**RE: *Item 10.2 – October 20, 2020 City Council Agenda:
C19-013, CP19-013 and T20-015 – Conforming Rezoning, Conditional Use Permit,
and Tentative Map for Certain Real Property Located at 550-570 Meridian Avenue,
1401 Parkmoor Avenue, and 529, 592, and 691 Race Street***

San Jose Vasona Quiet Zone Diagnostic Review Comments & Responses

DATE: August 6, 2019 (Day 1)

DUPONT ST

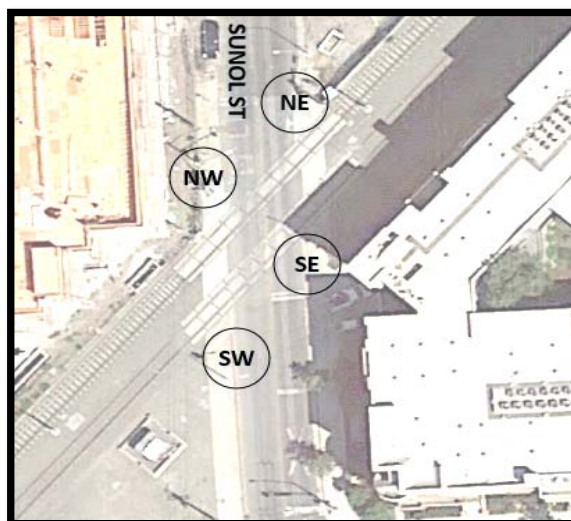
Comments		Response
<i>General</i>		
1	Crash History 2007 - 2019: none	n/a - informational comment
2	Land Uses: trail and residential multifamily at southeast quadrant; residential multifamily developments proposed at southwest and northwest quadrants	n/a - informational comment
3	This crossing is a good candidate for closure to regular vehicular traffic on the east leg since it dead-ends	Placement of a barricade along the west side of the tracks with 8.5' side clearance from the track was evaluated and deemed infeasible because the eastbound left turn movement overlaps with the rail envelope.
4	This is a 4-quadrant gate system without vehicle presence detection; current CPUC standard is to have vehicle presence detection; if any electrical alterations were made to this system, CPUC would require vehicle presence detection to be incorporated	n/a - informational comment
5	While diagnostic review was being conducted, a bicyclist ignored activated warning devices and rode through the crossing	n/a - informational comment

<i>SE quadrant</i>		
6	There is no sidewalk in between the tracks on the south side of the street; this leads pedestrians to enter the roadway in order to cross the tracks; connect the sidewalk over the tracks to keep pedestrians on the sidewalk	City staff and VTA are coordinating to seek developer contributions towards sidewalk and pedestrian treatments as part of the proposed developments on the southwest quadrant of the crossing.
7	The gate is missing bells and missing flashers facing eastbound	See Dupont Comment Response #6. Addition of bells and flashers could be incorporated into the improvements.
8	Signage ineffective – doesn't tell pedestrian what they need to do – there is no channelization	See Dupont Comment Response #6.
<i>NE quadrant</i>

9	There is a staircase connecting Dupont St with the San Carlos St Bridge; there is no sidewalk on the north side of Dupont St, and the staircase offloads pedestrians into the roadway; there is no channelization for pedestrians headed across the tracks; improve	See Dupont Comment Response #6 for planned improvements. In the longer term, the Diridon Station Integrated Concept Plan is a joint planning effort by City of San Jose, VTA, CA High Speed Rail Authority, and Caltrain to redesign Diridon station. On December 3, 2019, San Jose City Council endorsed the plan's recommended spatial layout of the station, which includes elevating the station. The raised station requires removal of the San Carlos Street Bridge and staircase, and a complete redesign of the Dupont Street crossing.
10	There is a chain link fence along the north edge of Dupont St at this quadrant; the fence is obstructing view of the warning signs; remove fence or push it north away from roadway	Caltrain placed the fence there temporarily during a construction project. The fence has been removed.

<i>NW quadrant</i>		
11	Gate is missing flashers facing east, and missing bells	Comment for VTA. Also see Dupont Comment Response #9.
12	Gate does not meet current MUTCD standard clearance requirement of 4'3" between the center of the pole and the face of curb	Comment for VTA. Also see Dupont Comment Response #9.
13	Gate does not meet current standard clearance required between the counterweight and the bridge pier	Comment for VTA. Also see Dupont Comment Response #9.
14	Roadway appears to be recently paved; verify required striping is put in place	Required pavement markings were recently installed (Fall 2019) on the north and west legs.
15	Need W-48CA (2 Tracks) underneath the W10-4	See proposed signage and striping plans in Attachment K. This sign will be added.
<i>SW quadrant</i>		
16	Check height of flashers – appears low	Comment for VTA.
17	Check pole clearance to face of curb	Comment for VTA. Also see Dupont Comment Response #9.

18	Especially because of the track skew, future development on the private property at this corner should maximize pedestrian line of sight down the tracks to see oncoming trains	City staff will carry this comment through the development review cycle for the proposed development adjacent to the southwest quadrant of the crossing. The latest plan submittal for the development shows the northeast corner of the proposed building setback approximately 35' west from the nearest track and 40' south from the existing face of curb.
19	Visibility – Trees	The existing trees at the northeast corner of the lot adjacent to the rail corridor will be removed by the proposed development. We will also ensure that the development does not place trees or other obstacles near the crossing that would obstruct line of sight down the rail corridor.

SUNOL ST

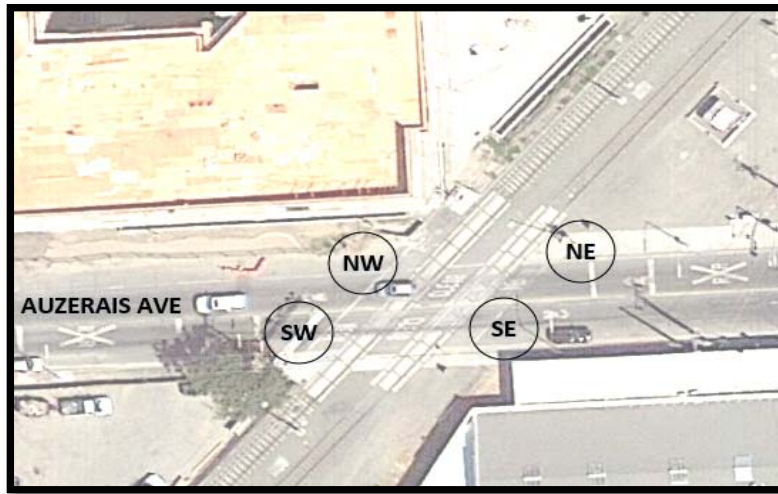
Comments		Response
<i>General</i>		
1	<p>Crash History 2007 - 2019:</p> <ul style="list-style-type: none"> • 3/12/13 Injury: southbound pedestrian in northeast quadrant hit by northbound LRT; pedestrian suffered injuries when pedestrian entered crossing against activated warning devices and was struck by the LRT • 6/8/13 Fatality: southbound bicyclist in northwest quadrant hit by northbound LRT; bicyclist rode into crossing against activated warning devices and was struck and killed by LRT 	n/a - informational comment
2	<p>Land Uses: This area used to be industrial; now high density residential and a nearby park, which will generate more pedestrian traffic</p>	n/a - informational comment
3	<p>Adjacent developments and anticipated pedestrian traffic warrant full pedestrian treatments (automated pedestrian gate, pedestrian swing gate, channelization, and detectable warning strip) at all quadrants</p>	See Attachment L for proposed gates. Pedestrian treatments at all quadrants are proposed.

4	<p>History: There were a few meetings at Sunol and Auzerais crossings in the past to improve the crossing with the new development; VTA, CPUC, and construction inspectors from CSJ attended; developer always disappeared following CPUC and VTA comments; CSJ needs a process to condition upgrades to crossings in planning phase of developments; recently, CSJ obtained \$1M from the developer to use towards improvements at the Sunol and/or Auzerais crossings; CSJ is coordinating with VTA to have VTA construct comprehensive improvements as part of their Pedestrian Back Gates Project and be reimbursed by CSJ</p>	See General Comment Response #14.
5	<p>4 quadrant gate system is the only SSM available due to driveways</p>	See Attachment L for proposed gates. A 4-quadrant gate system is proposed.
<i>SE quadrant</i>		
6	<p>Refresh pavement markings for northbound direction</p>	See proposed signage and striping plans in Attachment K. These pavement markings will be refreshed.

7	NB stop bar doesn't appear compliant; new requirement is a single 24" wide bar	See proposed signage and striping plans in Attachment K. This stop bar will be replaced.
8	There is a driveway that appears to just serve trash collection; this is a bad location just south of the crossing because trash collection vehicles can block traffic's view of the crossing; some vehicles could circumvent the trash collection vehicle and enter the rail crossing when trains are approaching; close this driveway or install a 4-quadrant gate system to mitigate this risk	We reached out to the Monte Vista property management and HOA and offered to close the driveway at no cost to them. They considered it but ultimately decided not to close the driveway because of concerns with using another driveway for trash collection.
9	Remove the two trees on the sidewalk on the east side of Sunol, south of the crossing; these trees block view of the crossing warning devices	The trees in question are juvenile specimens. At maturity, these trees will have a height of over sixty feet and will allow the crown to be maintained at our standard fourteen feet over the roadway to provide adequate clearance for larger vehicles and should not present a long term issue for visibility at the crossing. In the interim, these trees have been raised to between eight and ten feet to provide visibility of the warning signs and devices. This will likely stimulate additional upward growth at the top and allow for a more permanent clearance pruning in 2-3 years.

<i>NE quadrant</i>		
10	Remove "No Left Turn" sign facing northbound traffic since there is no longer a driveway to turn into	See proposed signage and striping plans in Attachment K. This sign will be removed.
11	The slatted fence along the rail corridor blocks views for southbound traffic of trains coming from the north; remove or replace with a fence that doesn't block visibility	Comment for VTA.
12	Remove the nonstandard "No Train Horn" sign that is mounted on the streetlight pole	See proposed signage and striping plans in Attachment K. This sign will be removed.
13	There is an Emergency Vehicle Access driveway within 60 feet of the crossing; this is problematic because vehicles using this driveway can cause downstream traffic to queue over the tracks	See Attachment L for proposed gates. A 4-quadrant gate system is proposed.
<i>NW quadrant</i>		
14	Replace defective gate arm (immediate action item unrelated to quiet diagnostic meeting)	VTA replaced the defective gate arm immediately after the diagnostic meeting.

15	Missing required warning signage and pavement markings; install immediately	RXR pavement marking has since been installed. A missing W48(CA) sign will be installed (Attachment K).
16	There is no ADA path to the crossing- create an ADA path approaching and into the crossing	See Attachment L for proposed gates. Pedestrian treatments, including expanded sidewalk, are proposed.
17	What type of wall is the developer installing along the rail corridor? It should allow visibility of the rail corridor	The developer installed a chain link fence; it allows for visibility between the sidewalks and rail corridor
18	Is the lower traffic signal head mounted at a compliant height? Appears very low	We reviewed all locations where there is a pole-mounted traffic signal head at a low height over the sidewalk (Sunol, Race, Parkmoor, Fruitdale, Leigh, Stokes). These supplemental signal faces provide extra visibility for drivers of the pre-signal indication. After the striping and signage plans and other planned improvements are implemented, we will evaluate whether these signal heads still provide a benefit or should be removed.

19	Why is there a bollard in the middle of the sidewalk; can it be removed	See Sunol Comment Response #18. The bollard channelizes pedestrians away from walking into the pole-mounted traffic signal head. If City staff determine that this signal head should be removed after improvements are completed, the bollard will be removed with it.
20	Installing complete pedestrian treatments might require relocating the Commission Standard #9 gate closer to the roadway in order to have room behind for the pedestrian treatments	n/a - informational comment
<i>SW quadrant</i>		
21	Fence off all sides of the triangular parcel at the northwest corner of the Auzerals/Sunol intersection to prevent trespassing onto the rail corridor and to help channelize pedestrians to the pedestrian crossings	The adjacent developer is preparing a proposal for improving this triangular parcel. We asked the developer to include channelization elements that deter trespassing.

22	Ensure that the sidewalk approach matches up with recommended widened sidewalk coming from the other side of the tracks	See Attachment L for proposed gates. Pedestrian treatments, including expanded sidewalk, are proposed.

AUZERAIS AVE

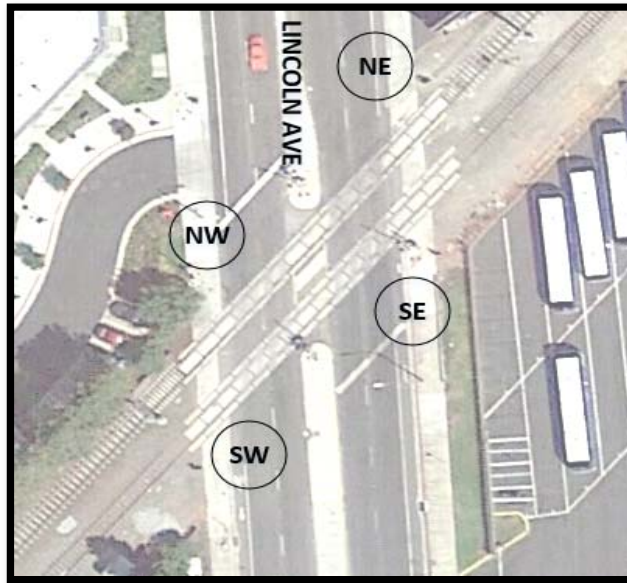
Comments		Response
<i>General</i>		
1	Crash History 2007 - 2019: none	n/a - informational comment
2	Land Uses: This area used to be industrial; now it is under construction for high density residential and there is a nearby park, which will generate more pedestrian traffic	n/a - informational comment
3	Adjacent developments and anticipated pedestrian traffic warrant full pedestrian treatments (automated pedestrian gate, pedestrian EXIT swing gate, channelization, and detectable warning strip) at both quadrants on the north side	See Attachment L for proposed gates. Pedestrian treatments are proposed on the north side, but not the south side because of the sidewalk gap. The City would seek new sidewalk and pedestrian treatments on the south side as part of future development applications on the adjacent parcels.
4	Refresh pavement markings (Keep Clear, stop bar, etc.) and ensure up to current standard	See proposed signage and striping plans in Attachment K. Pavement markings, especially stop bars and crosswalks, will be updated to current standard. Faded pavement markings will be refreshed.

5	History: There were a few meetings at Sunol and Auzerai crossings in the past to improve the crossing with the new development; VTA, CPUC, and construction inspectors from City of San Jose attended; developer always disappeared following CPUC and VTA comments; CSJ needs a process to condition upgrades to crossings in planning phase of developments; recently, CSJ obtained \$1M from the developer to use towards improvements at the Sunol and/or Auzerai crossings; CSJ is coordinating with VTA to have VTA construct comprehensive improvements as part of their Pedestrian Back Gates Project and be reimbursed by CSJ	See General Comment Response #14.
6	Proper pedestrian channelization is missing	See Auzerai Comment Response #3.
7	ADA access needs to be addressed	See Attachments K and L. The proposal is to keep pedestrians on the north side of Auzerai between Lincoln Ave and Sunol St. DOT will connect the existing sidewalk gap on the north side of Auzerai to the west of the crossing using striping.

8	Fence off all sides of the triangular parcel at the northwest corner of the Auzerais/Sunol intersection to prevent trespassing onto the rail corridor and to help channelize pedestrians to the pedestrian crossings	The adjacent developer is preparing a proposal for improving this triangular parcel. We asked the developer to include channelization elements that deter trespassing.
<i>NW quadrant</i>		
9	There is a gate arm for a driveway that used to exist but was removed with the new development; the driveway gate extended into the roadway as well, functioning as a quasi-exit gate the developer wanted to remove the gate arm, and met with CPUC and VTA; CPUC wanted the developer to install pedestrian treatments as part of the work; the developer disappeared; City and VTA are coordinating on comprehensive improvements at this crossing as part of VTA's Pedestrian Back Gates project	A GO88b was issued to CPUC and CPUC provided approval to remove the gate arm. VTA has a contractor on board who is working on the programming that needs to be adjusted before the obsolete gate arm can be removed.

10	VTA recently determined that this third gate arm is a pedestrian collision hazard; the gate comes down 7 seconds after the other gates (to allow westbound vehicles to clear the crossing; with the new sidewalk installed, eastbound pedestrians are channelized towards this quadrant and could enter the crossing and get trapped on the tracks by the lowered gate; VTA and the developer have installed barricades on the sidewalk to deter pedestrians from crossing here; City and VTA are coordinating on a GO88 to remove the remnant gate arm in the near-term and re-open the sidewalk	See Auzerais Comment Response #9.
<i>SW quadrant</i>		
11	Replace W10-9P with the standard size consistent with your other locations	See proposed signage and striping plans in Attachment K. This sign will be replaced.
12	There is a tree on the private property side of the fence which is blocking visibility of the crossing warning devices and appears to be in contact with overhead electrical lines; remove this tree or trim it down substantially	This tree will be removed.

13	Remove "Road Construction Ahead" sign mounted on the PG&E pole if it is no longer needed	See proposed signage and striping plans in Attachment K. This sign will be removed.
14	The private property adjacent to this quadrant has a driveway cut; this driveway is too close to the crossing; close the driveway and replace with sidewalk and curb	The owner has agreed to let the City close the two existing driveways on the southwest quadrant of the crossing and install one new driveway at the west edge of the property approximately 120 feet away from the gate arm. See Attachment K.
15	prohibit parking on the curb all the way to the crossing from the property's other driveway	See proposed signage and striping plans in Attachment K. This curb will be painted red.
16	check distance that warning signs are placed relative to crossing	Warning signs are located approximately 90 feet from the stop bar which is consistent with CA MUTCD Table 2C.4 guideline of 100 feet advance placement distance for a street with a 25 mph speed limit.

| 17 | add a No Sidewalk barricade at an appropriate location between this quadrant and Lincoln Ave | See proposed signage and striping plans in Attachment K. Signs are proposed at Lincoln Ave and at Sunol St to direct pedestrians to use the norht side of Auzerais Ave. |

| | add a No Sidewalk barricade between this quadrant and Sunol St. | |
| 18 | CPUC recommends the barricade be installed at the Sunol and Auzerais intersection | See Auzerais Comment Response #17. |
| 19 | red curb from intersection to crossing | See Auzerais Comment Response #15. |

LINCOLN AVE

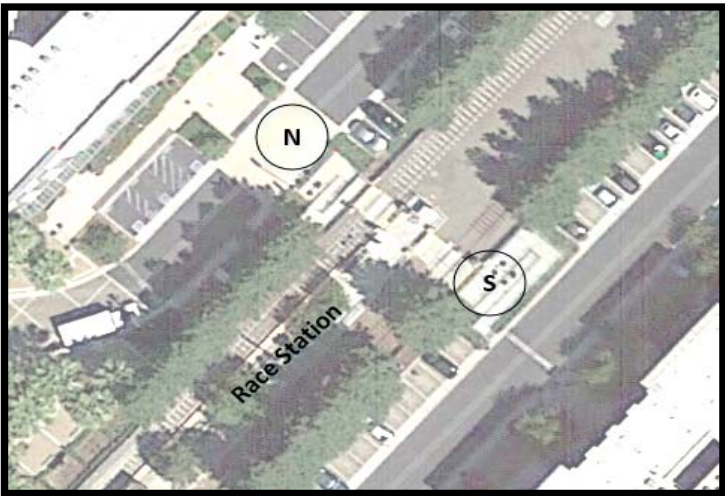
Comments		Response
<i>General</i>		
1	Crash History 2007 - 2019: • 7/8/18 Double Fatality: driver of vehicle ignored activated warning devices, drove vehicle through gate arms and was struck by LRT, killing both the driver and the passenger of the vehicle	n/a - informational comment
2	Land Uses: multifamily residential, medical, industrial, commercial	n/a - informational comment
3	Driveways to adjacent properties are too close to crossings	The City is working with the property management to close the driveway at the northeast quadrant pending agreement from tenants and Fire Department, and a new parking site plan. If the driveway cannot be closed, City will request that it be marked right-out, exit-only.
4	Any access to adjacent properties that is 60 feet or less from the crossing needs to be eliminated	See Lincoln Comment Response #3. Our quiet zone application proposes a partial risk reduction for the ASM at this crossing due to the driveways.

5	A 4-quadrant gate system would be ideal here because of the cars driving at higher speeds, because of the adjacent driveways on both north quadrants, and because of the adjacent alcoholic establishment	See Lincoln Comment Response #4.
6	Pedestrian gates not prioritized at this location as it does not appear to have high pedestrian flows	n/a - informational comment
7	While diagnostic review was being conducted, a bicyclist ignored warning devices signaling a train was coming and went through the crossing as arm gates were coming down	n/a - informational comment
<i>SE quadrant</i>		
8	change W10-9P sign to our current standard	See proposed signage and striping plans in Attachment K. This sign will be replaced.
9	relocate bus stop and bus stop sign	VTa removed this bus line in December 2019 as part of a new transit service place.

10	gate on sidewalk is missing flashers facing north	Comment for VTA.
11	the gate in the sidewalk and the warning signs crowd the sidewalk and could lead to pedestrians walking behind the sidewalk around the control devices; suggest relocating warning signs and adding pedestrian channelization	See proposed signage and striping plans in Attachment K. The R15-8 sign will be removed.
12	warning signs look big; check dimensions	See proposed signage and striping plans in Attachment K. The R15-8 sign will be removed. The W82-1(CA) and W10-9P signs conform to CA MUTCD size requirements.
<i>NE quadrant</i>		
13	the adjacent plaza has 3 driveways on Lincoln and one driveway on Auzerai; the driveway just north of the crossing is located very close to the tracks and raises the risk of a vehicle driving in opposing traffic across the tracks; also, the establishment in the plaza that is closest to the tracks is an alcoholic establishment; close this driveway if possible	See Lincoln Comment Response #3.

14	if the driveway cannot be closed, add a median mounted "Right Turn Only" sign, stripe the driveway as a right turn out only, add edge lines in the driveway to guide vehicles to turn right out, and modify the driveway to physically force vehicles to turn right as they exit	If the driveway cannot be closed, City will request that it be marked right-out, exit-only, and City will evaluate locating a "Right Turn Only" sign in the median.
<i>NW quadrant</i>		
15	check W10-9P sign for consistency	See proposed signage and striping plans in Attachment K. This sign will be replaced.
16	the residential development should not have been allowed to locate the driveway within proximity of the tracks	See General Comment Response #14.
17	check ADA compliance around gates	This crossing in general was not considered to have high pedestrian volumes and thus was not prioritized for pedestrian treatments.
18	widen the sidewalk to the back to open up an ADA path for pedestrians around the gate	See Lincoln Comment Response #17.

19	the tree right next to the gate is overgrown and blocking visibility of the warning devices; remove it or trim it back considerably and maintain regularly	The City will trim this tree, or follow up with the property management for tree trimming.
20	warning signs look big; check dimensions	See proposed signage and striping plans in Attachment K. The R15-8 sign will be removed. The W82-1(CA) and W10-9P signs conform to CA MUTCD size requirements.
21	gate is missing flashers facing south	Comment for VTA.
<i>SW quadrant</i>		
22	the visibility between this quadrant and the rail corridor is limited because of the tracks skew and trees lining the rail corridor; flashers and bells are needed at this quadrant	Comment for VTA. VTA is considering pedestrian treatments here as part of their Pedestrian Back Gates project.

RACE STATION

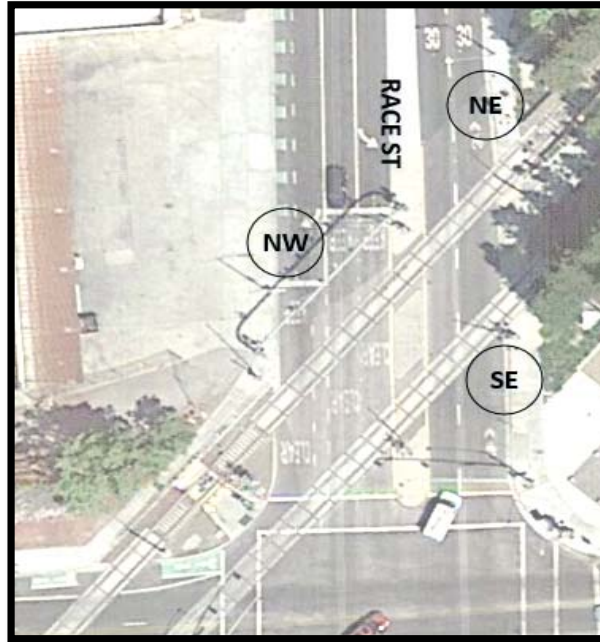
Comments		Response
General		
1	Crash History 2007 - 2019: none	n/a - informational comment
2	Land Uses: high density residential both sides	n/a - informational comment
3	Detectable warning strips should be outside of the gates; currently they are inside the gates which can give the wrong impression to a vision-impaired user that they are within a “safe zone”	Comment for VTA.
4	The north side of the crossing doesn’t have flashers positioned in advance of the gates; Install Commission Standard #8 flasher	Comment for VTA.

RACE ST

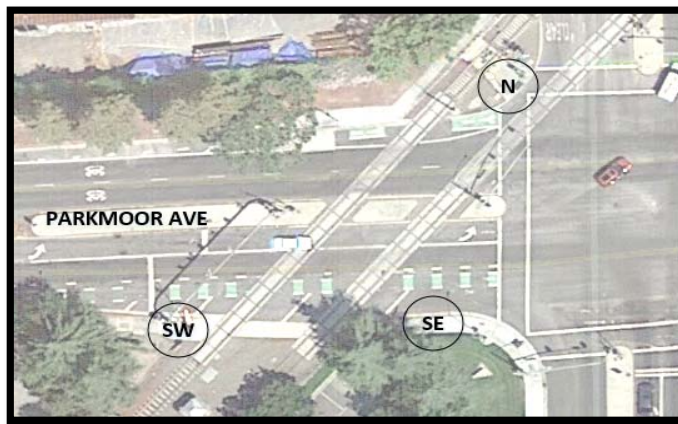
Comments		Response
<i>General</i>		
1	Crash History 2007 - 2019: •2/4/12 Injury: pedestrian suffered injuries when pedestrian entered the crossing while the warning devices were activated and was struck by LRT	n/a - informational comment
2	Land Uses: high density residential and Light Rail station on east side; proposed school with 2700 students on west side; a recently opened school resides on the opposite corner (SE) on the Race and Parkmoor intersection	n/a - informational comment
3	The property on the west side of Race St is proposed for redevelopment into a school of 2700 students; CSJ's conditions on the property redevelopment require the school to utilize crossing guards during school drop off and pick up, to conduct at least annual crossing safety trainings	n/a - informational comment
4	Loading zones, school buses, etc. should be located as far away from the tracks as possible	City staff will carry this comment through the development review cycle for the proposed development on the northwest corner of Race/Parkmoor. The latest plan submittal for the development shows an ingress only driveway on Race St approximately 400 feet north (upstream) of the tracks, and an egress-only driveway on Parkmoor approximately 200 feet west (downstream) of the tracks.

5	City of San Jose Traffic Safety Education Officer, Cordell Bailey, performs frequent trainings at schools in San Jose and will do so at this school after it opens; he is Operation Lifesaver certified	n/a - informational comment
6	This crossing overlaps with the Parkmoor crossing	n/a - informational comment
7	Pedestrian treatments suggested at all quadrants	See Attachment L for proposed gates. Pedestrian treatments at all quadrants are proposed.

8	FRA is concerned with these two crossings (Race & Parkmoor); track and intersection geometry is very challenging to mitigate; multiple collisions, especially at the northwest corner of the Race/Parkmoor intersection; existing school on the southeast corner of the intersection; and now a school going to open on the northwest corner of the intersection. This would be an ideal candidate for grade-separation of the light rail track (e.g. see LRT flyover at Hamilton Ave in San Jose).	The City developed a new plan line for Race St and Parkmoor Ave to improve this location. See Attachment L.
9	Per CPUC, this location would be an ideal candidate for a pedestrian overcrossing.	A pedestrian overcrossing is not preferred because it would require pedestrians to take a longer and less direct path and, is not expected to achieve high compliance at this location. Instead, this crossing will be reconstructed to improve safety for all users at-grade. See Attachment L.

10	FRA prepared a concept for a redesign of the intersection and crossings that they would like to share with the group	City obtained the concept from FRA. The concept relocates the north leg and west leg crosswalks to the north and west sides of the tracks, respectively. This was one of two concepts that City staff evaluated. City staff determined that in order for the crosswalks to operate safely and be protected from right-turning drivers, they would need to be signalized and have an exclusive pedestrian phase coinciding with an all-red for the rest of the intersection. City staff determined that this would yield an unacceptable impact on operations, noting that the signal already experiences all-red over 160 times per day with each LRT movement through the intersection. This type of impact would be expected to result in driver frustration and violations of the signals, which would put pedestrians at more risk. Instead, this crossing will be reconstructed per the concept in Attachment L.

11	City of San Jose geometrics team has prepared some concepts for a redesign of the intersection and crossings that we will share with the group after they have gone through internal city review	See Attachment L. This concept has been coordinated with FRA, VTA, and CPUC. The City will continue to coordinate the design with the stakeholders as it progresses.
12	Suggest adding a controlled crosswalk mid block north of the tracks and a minimum of 200 feet away the crossing to enable students/pedestrians to cross Race St between the school side and the LRT station side without having to cross the tracks	See Attachment L. City staff considered a mid block crosswalk on Race St north of the crossing, but ruled it out for safety reasons due to the three back-to-back left-turn pockets.
13	Overall, FRA understands that there are efforts underway to improve the crossing (proposed improvements to be conditioned on school development, CSJ geometrics team evaluating intersection reconfiguration options), and requests CSJ engage FRA and CPUC in that ongoing work	See Race Comment Response #11.

14	Median dividing northwest and northeast quadrants does not meet curb height requirements	The City of San Jose will add channelizers onto the median islands in the near term. In the long term, the median islands will be reconstructed to a minimum 8" height as part of the proposed development on the northwest corner of Race/Parkmoor.

15	Gate does not meet current MUTCD standard clearance required between the center of the pole and the face of curb	See Attachment L. This gate arm would likely be replaced.
<i>NW quadrant</i>		
16	The proposed development should not be allowed to have any driveways within 100 feet of the crossing	See Race Comment Response #4.
17	Southbound vehicles on Race often miss the stop bar for the pre-signal; need to refresh pavement markings; check if signage, pavement markings, etc. can be modified to yield higher driver compliance. Possible candidate to install crosshatch pavement markings.	See proposed signage and striping plans in Attachment K. In the near-term, the stop bar will be relocated and signal heads will be evaluated.
